ADDENDUM NO. 1

5th Street & Walnut St. Streetscape Improvements

Model Construction
1826 Race Street
Cincinnati, OH 45202

PROP. REPLACEMENT BASEPLATE FOR ODOT POLE #2 SECTION A-A

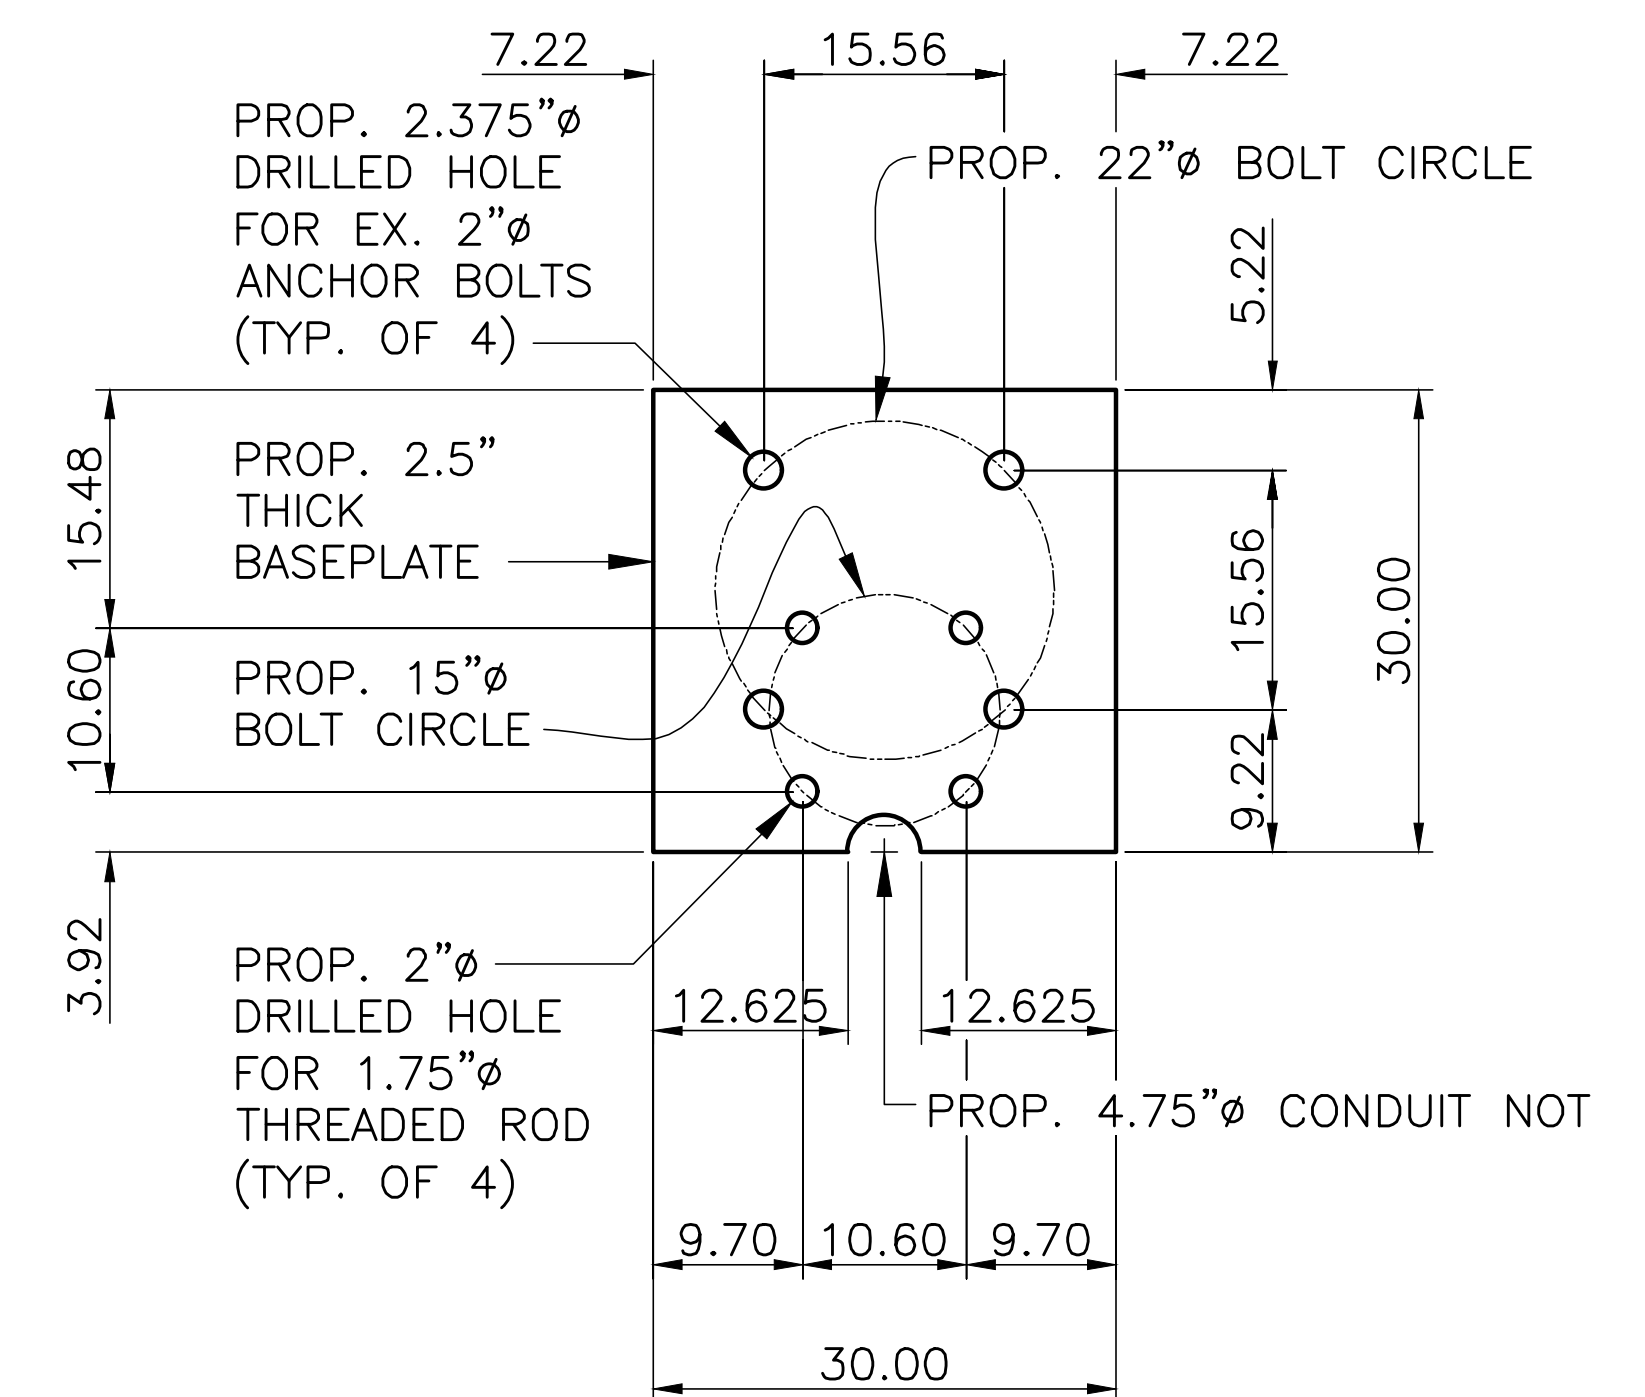
Install the new 2.5" thick baseplate with the pre-installed 1.7 diameter anchor rods attached. Anchor rods must extend the indicated length toward the top of the plate.

In the field, set the 2.5" thick plate over the existing bolts. Check tightness of the new nuts attaching the replacement rods.

**SPLIT SLAB SIDEWALK SECTION DETAIL @
EXISTING STRUCTURAL SLAB + NEW TOPPING SLAB**

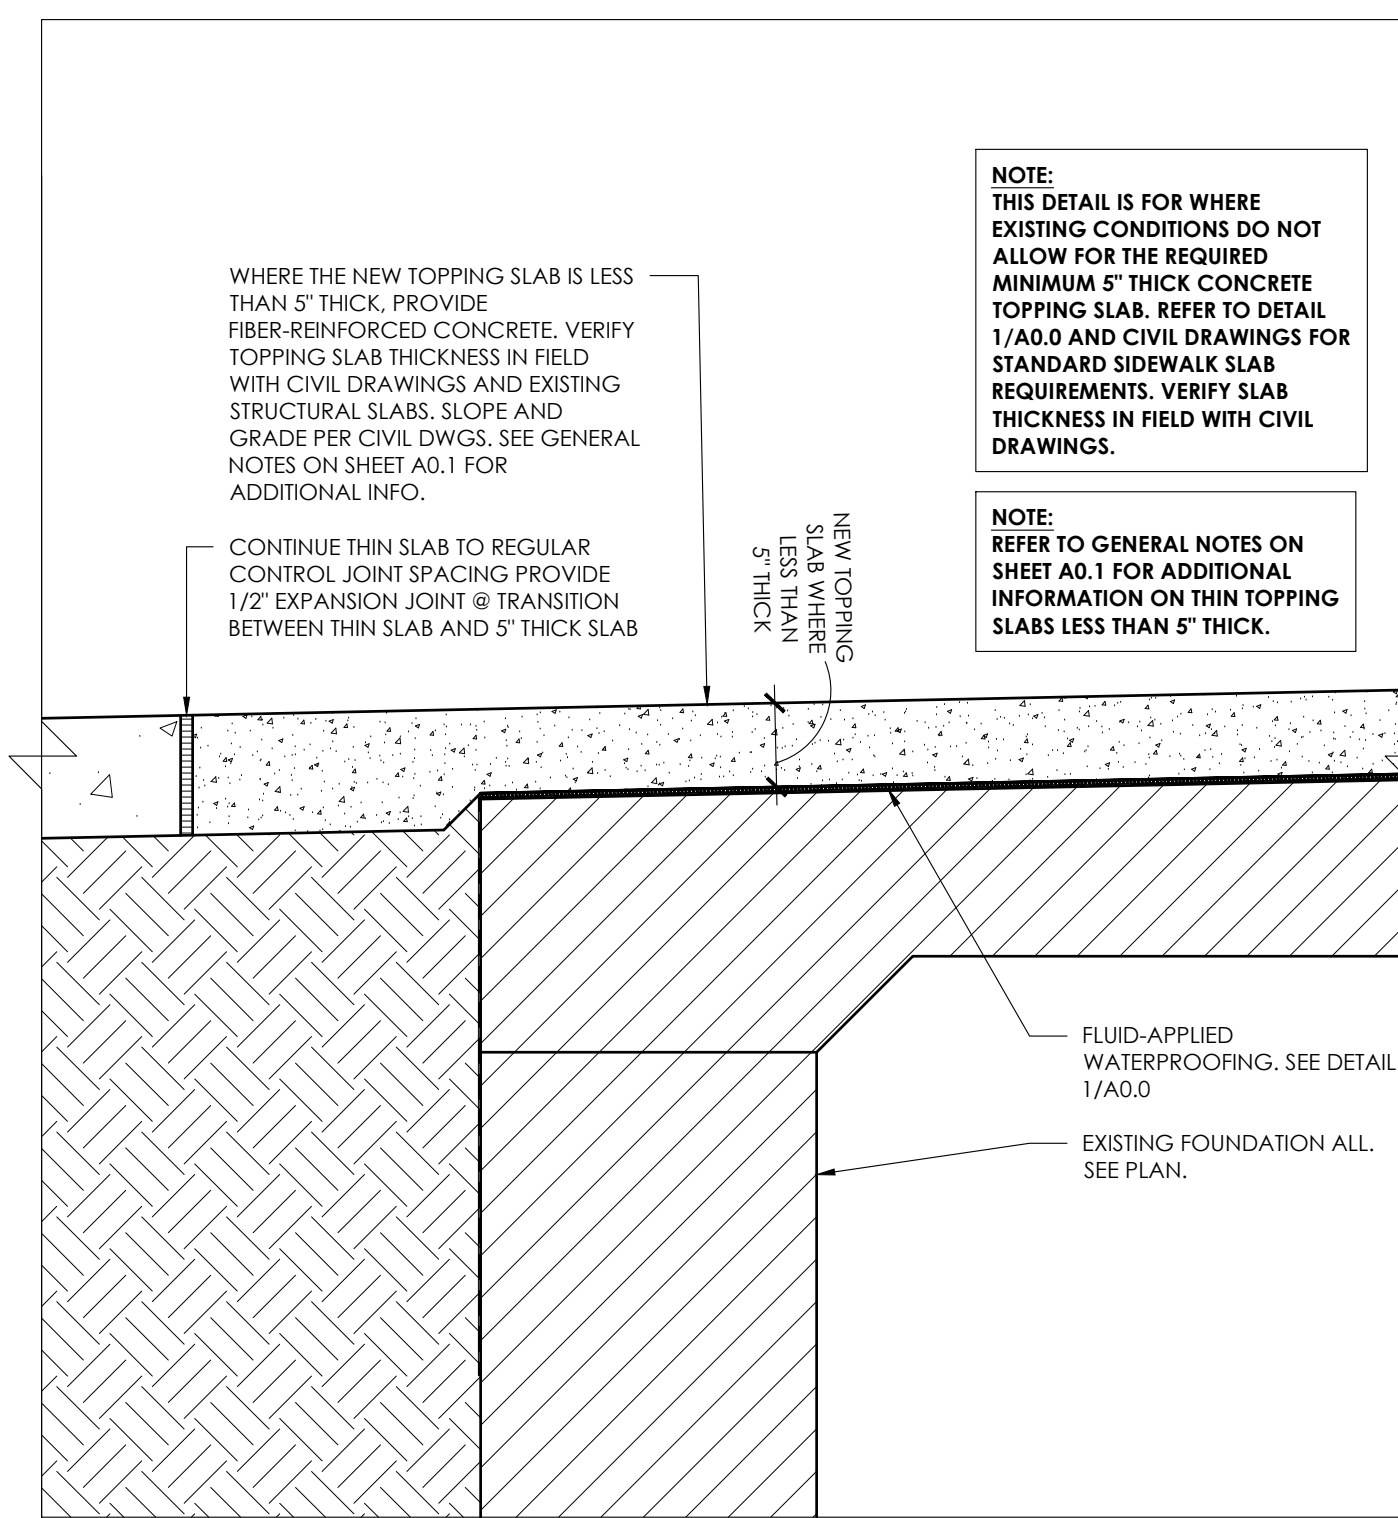
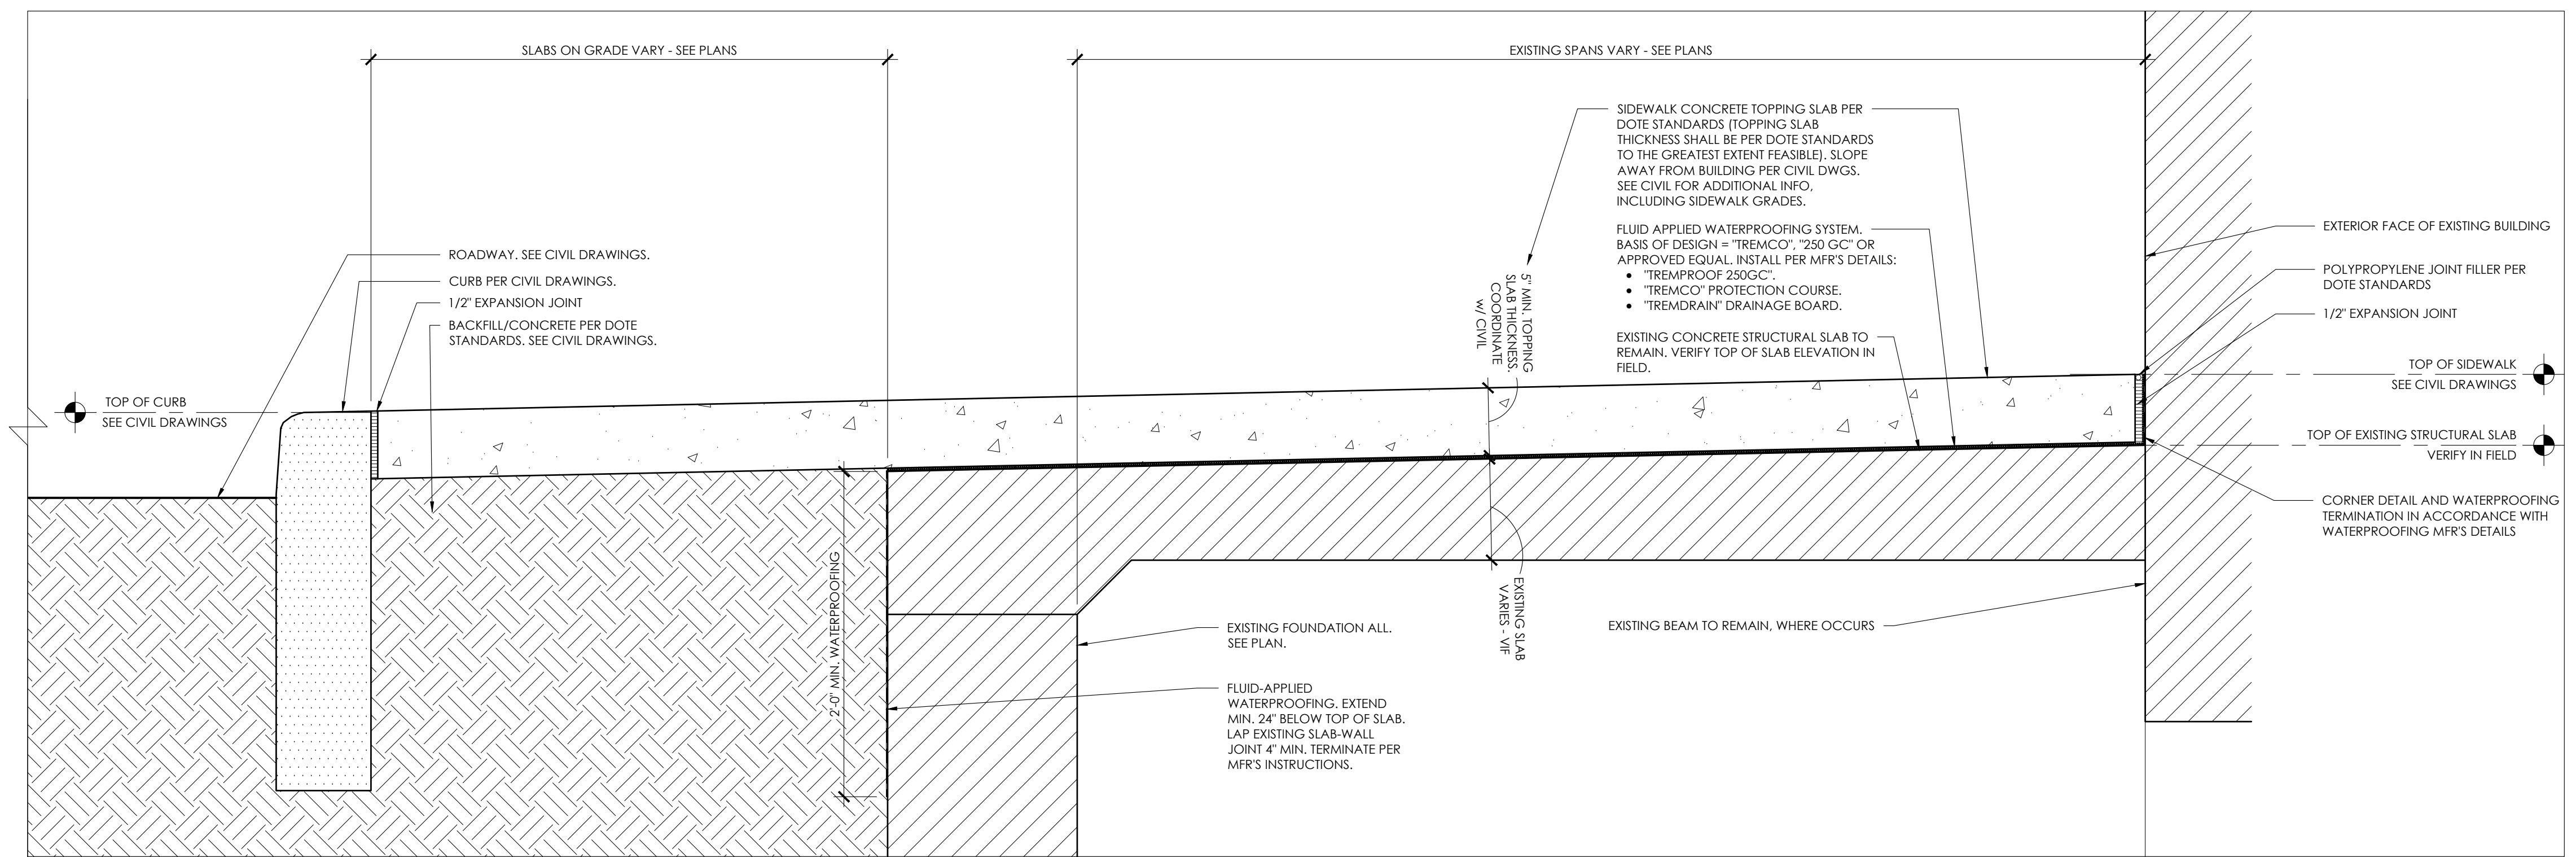
- a. Answer – Bidders shall include sounding existing concrete. All patching/repair work in these areas will be completed on Time & Material.
- 2- Drawing A0.2 – In regard to the topping slab, it is unknown the quantity of concrete that is under 5” requiring fibers vs over 5”. In order to provide an apples to apples bid, please provide a quantity of each.

- a. Answer – For bidding purposes, figure all topping slabs will be over 5” and will have mesh.
- 3- Drawing A0.1 – Note 11 calls for demo of existing bathrooms, is this included in our scope or by others? Note 23 calls for rerouting of existing utilities, is this included in our scope or by others?

SECTION 1
SCALE 3/4" = 1'-0" S310

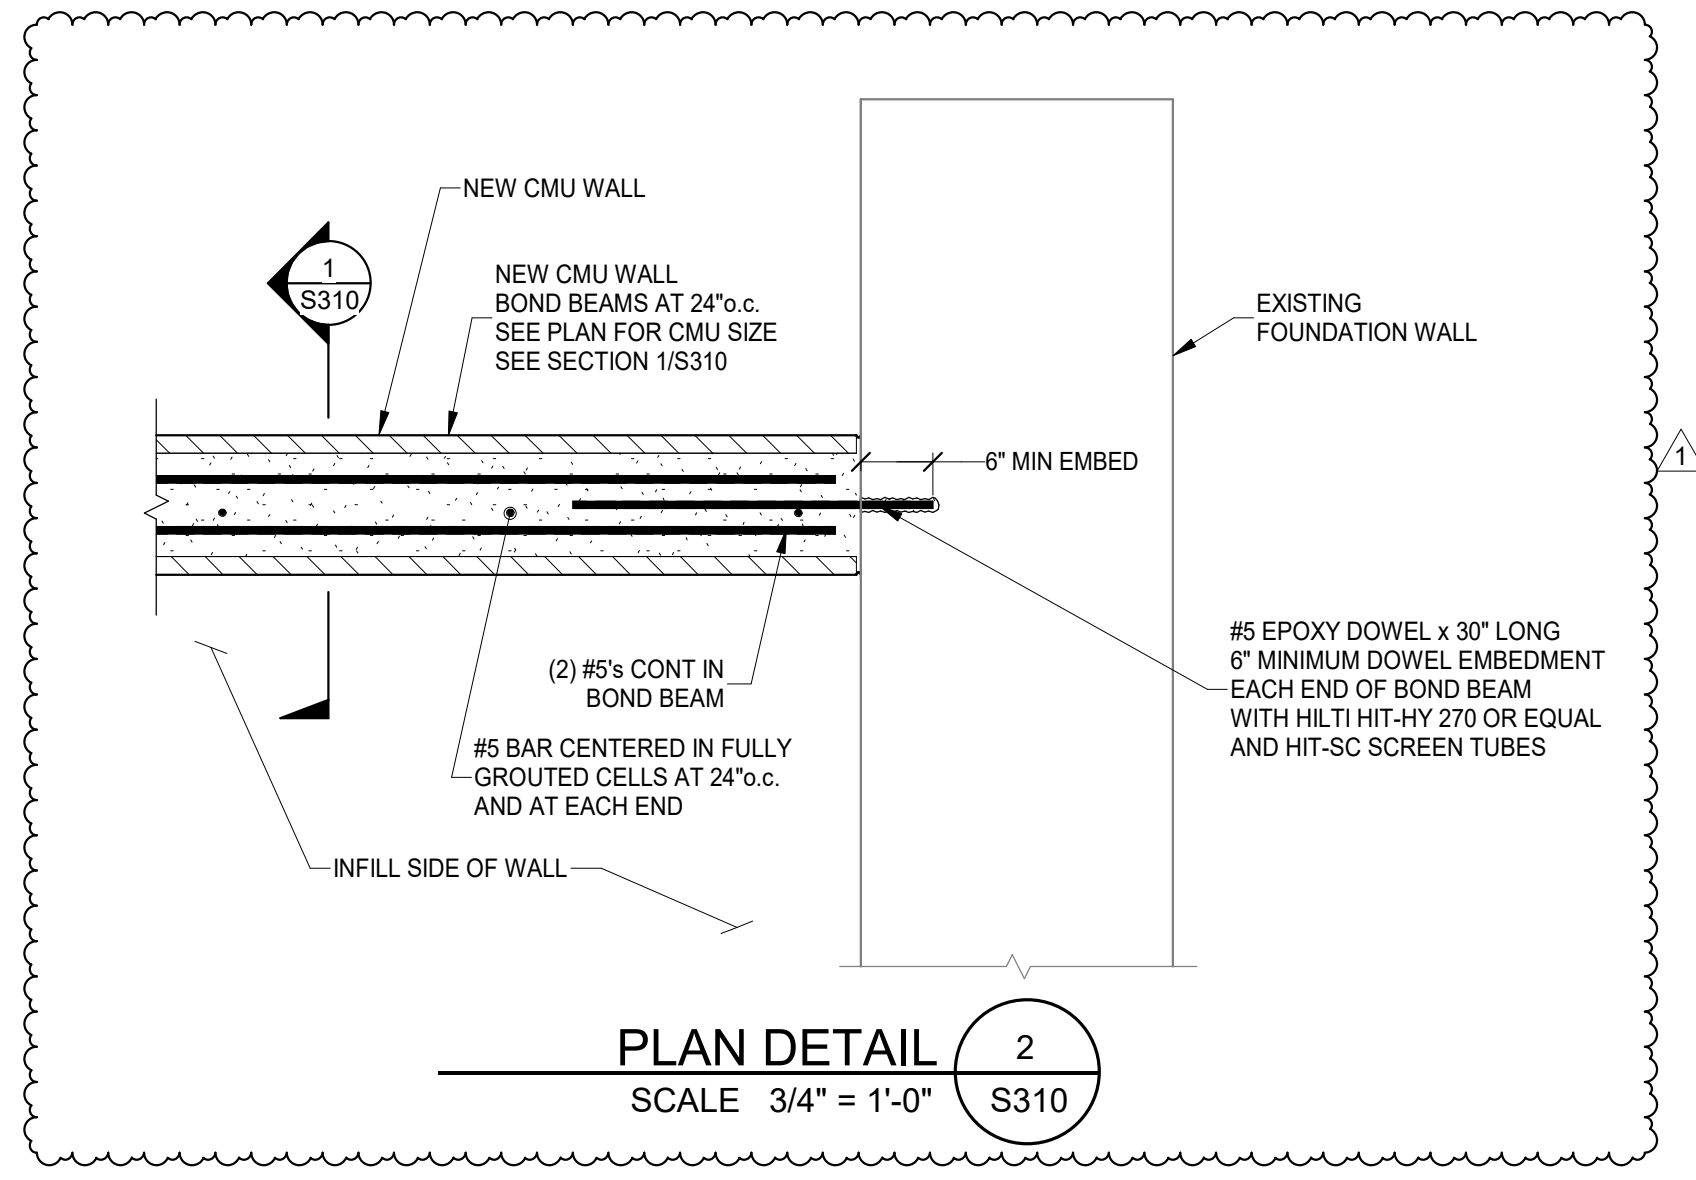
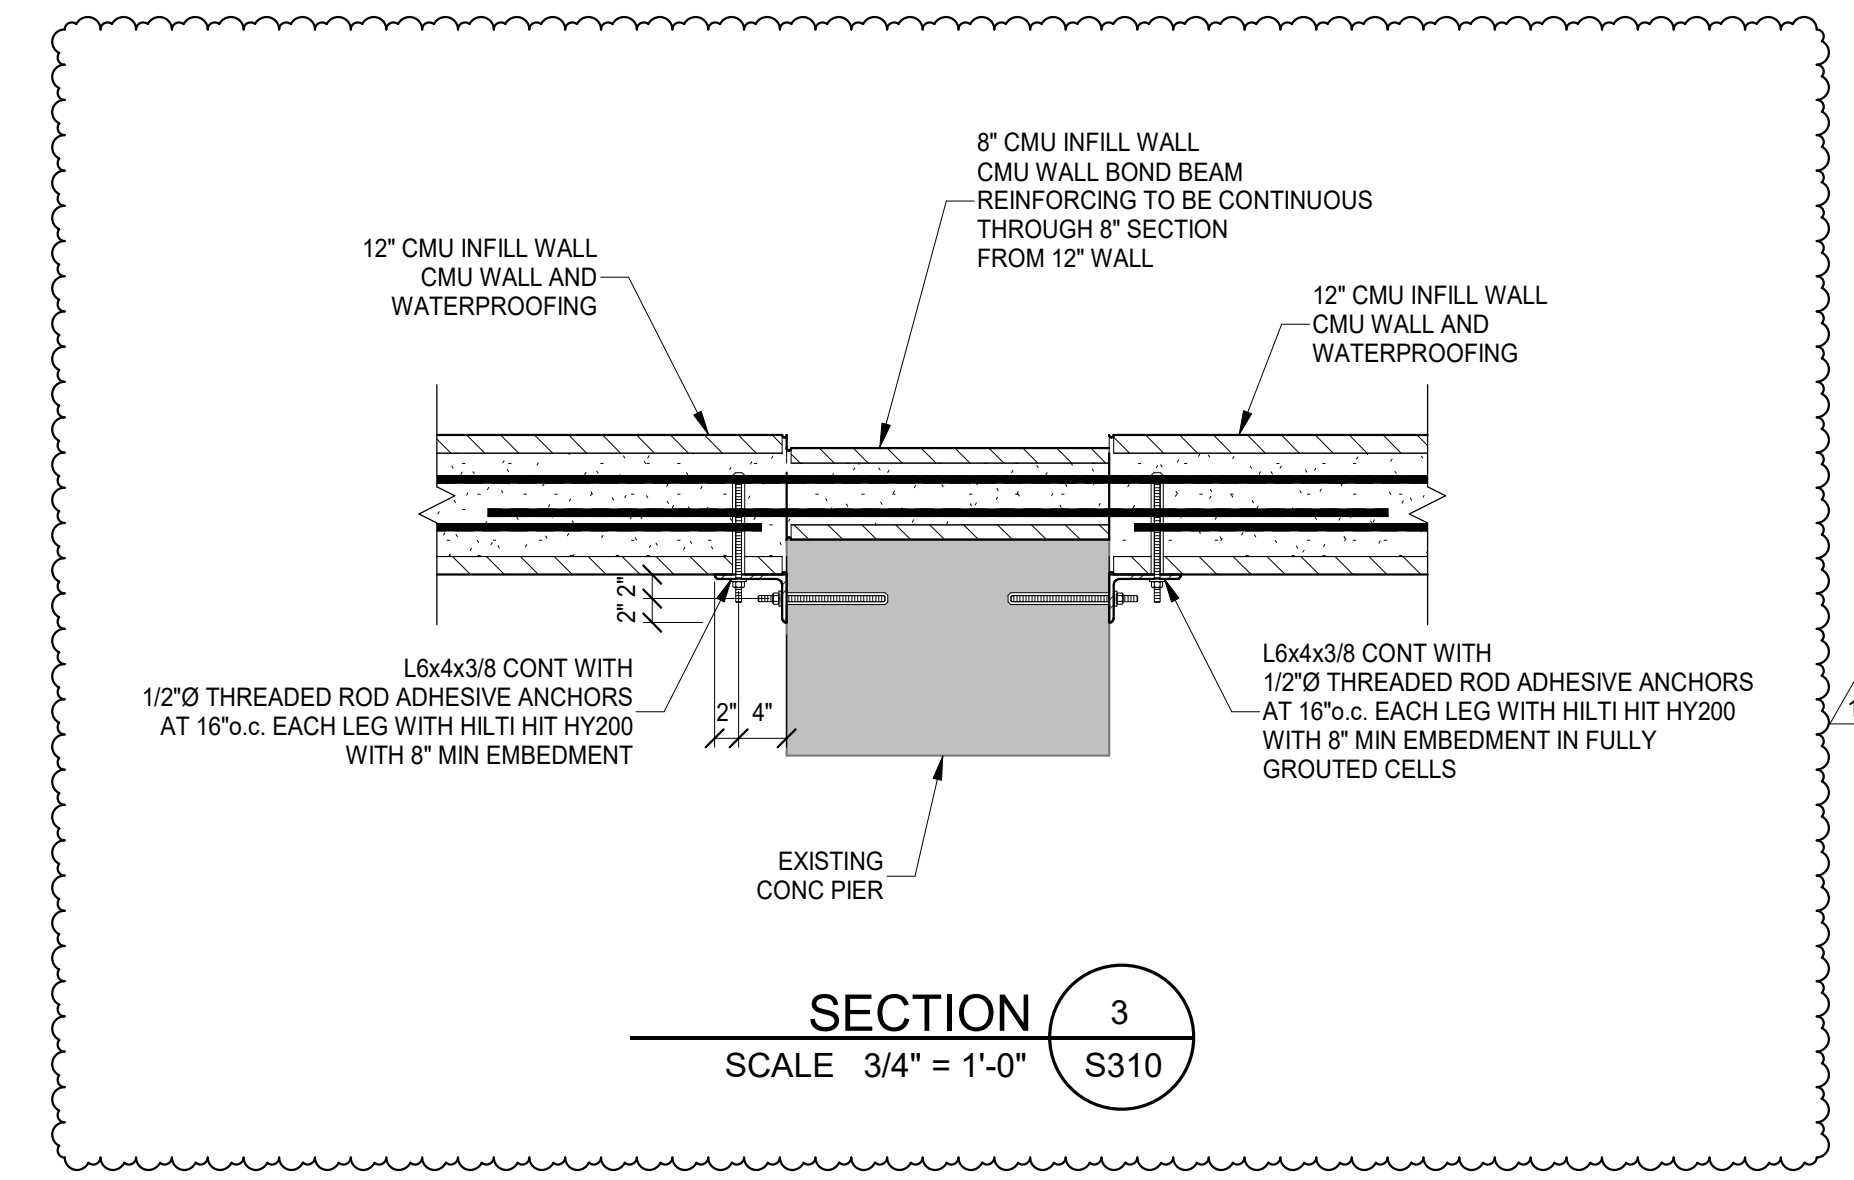
- a. Answer – Sidewalks can be poured continuously.
- 7- Drawing S310 – Could you provide a height of basement Encroachment area for CDF fill calculations?

- a. Answer – The height is 14’-0”.
